CARL FINLAY DRIVE

SITE PLAN REVIEW

OSTIENSE
CITY OF BRAMPTON

SITING
CARL FINLAY DRIVE
BLK 68/153

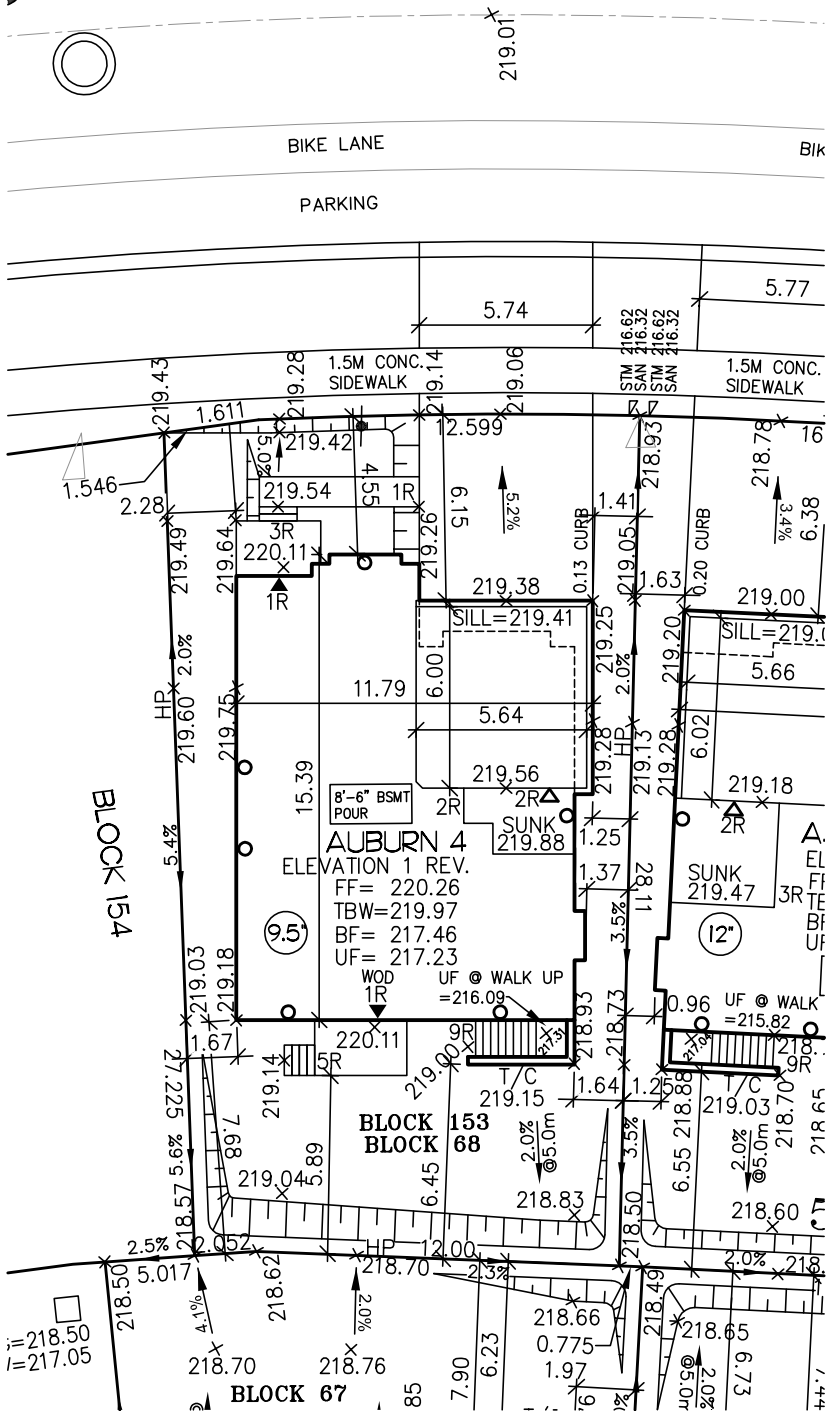
THE PROPOSED LOT GRADING AND DRAINAGE IS APPROVED AS BEING IN CONFORMITY WITH THE OVERALL APPROVED GRADING PLANS FOR THE SUBDIVISION.

COMMENTS AS NOTED
